MAINE TURNPIKE AUTHORITY

ADDENDUM NO. 2

CONTRACT 2021.07

EXIT 45 – INTERCHANGE

SHEET NUMBER: EQ-02
 CONTRACT: 2021.07
 4 OF 431

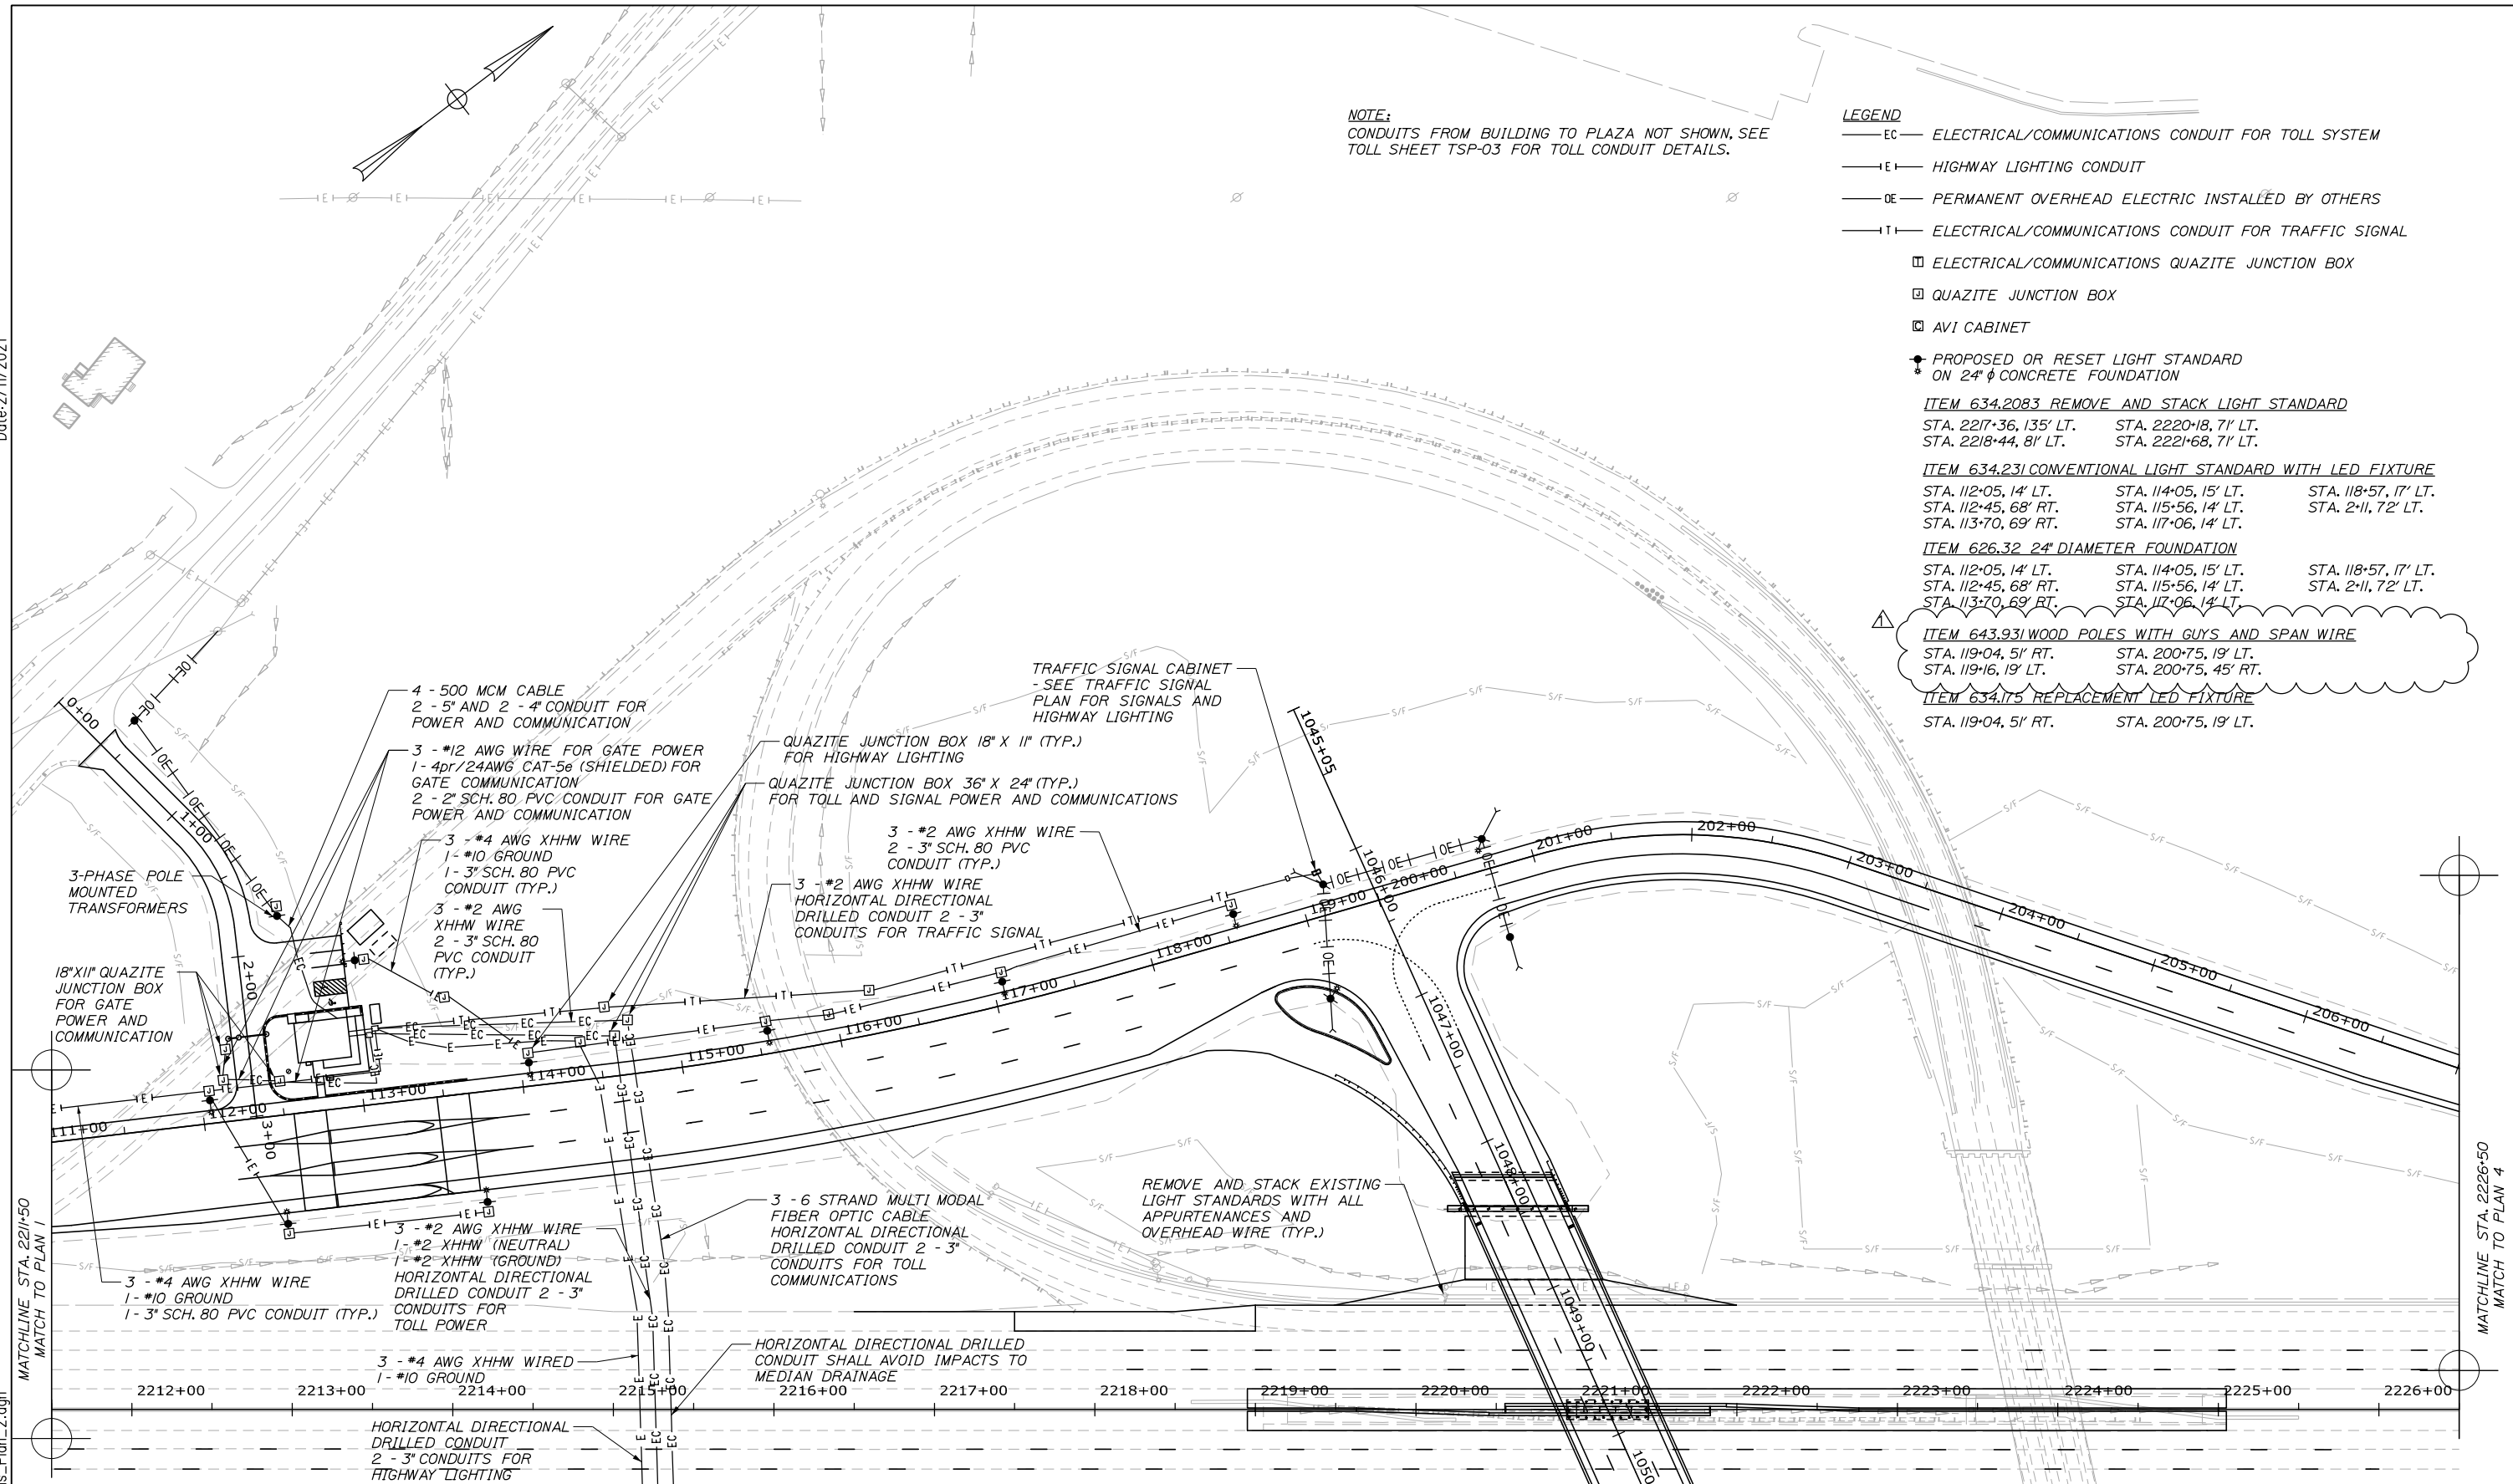
- Plan Sheet EQ-02 (4 of 431) is deleted and replaced with the attached.
- Plan Sheet CP-02 (117 of 431) is deleted and replaced with the attached.
- Make a pen and ink change to plan sheet TC-01 (344 of 431), Change Class AAA – Deck to Class AAA.

SHEET NUMBER: TSP-03

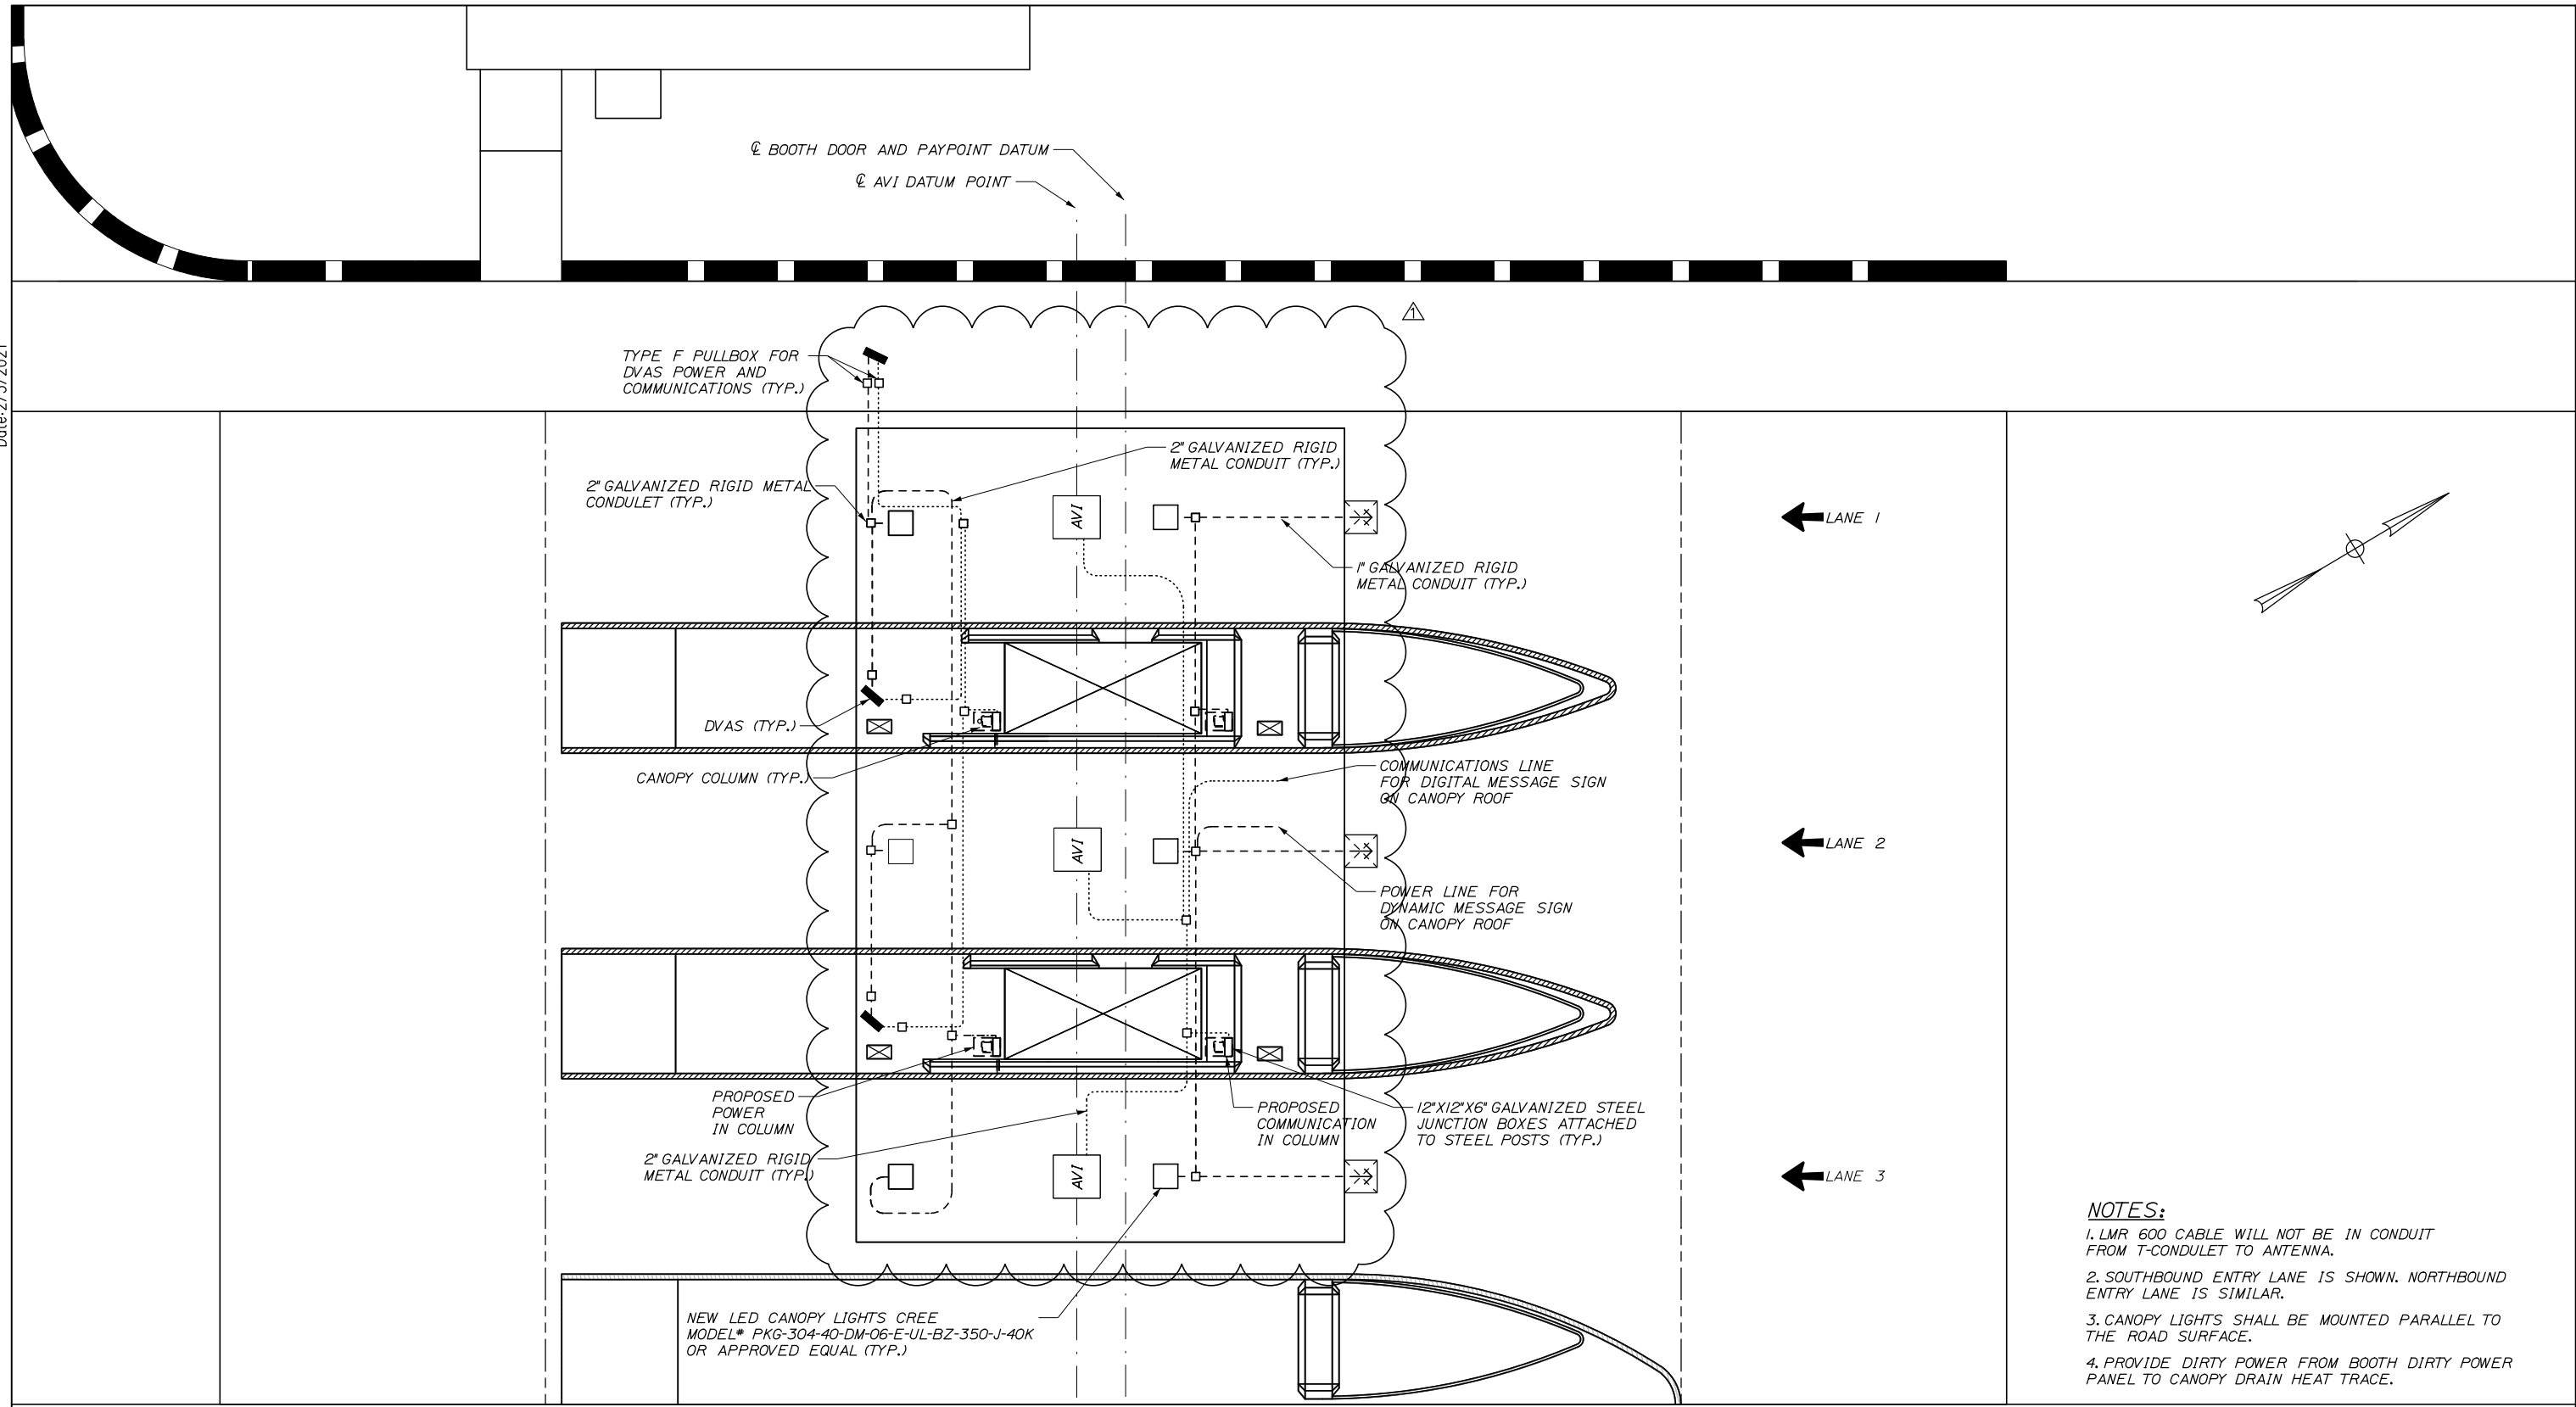
- Plan Sheets TSP-03 to TSP-04 (354-355 of 431) are deleted and replaced with the attached.
- Make a pen and ink change to Plan Sheet A01 (403 of 431) - RESTROOM 106 – Change the partition type at the wall common with Door 105 from partition type 4 to partition type 3.

No.	Revision	By	Date
1	UPDATED AVI CABINET AND NOTES	WWL	2/21
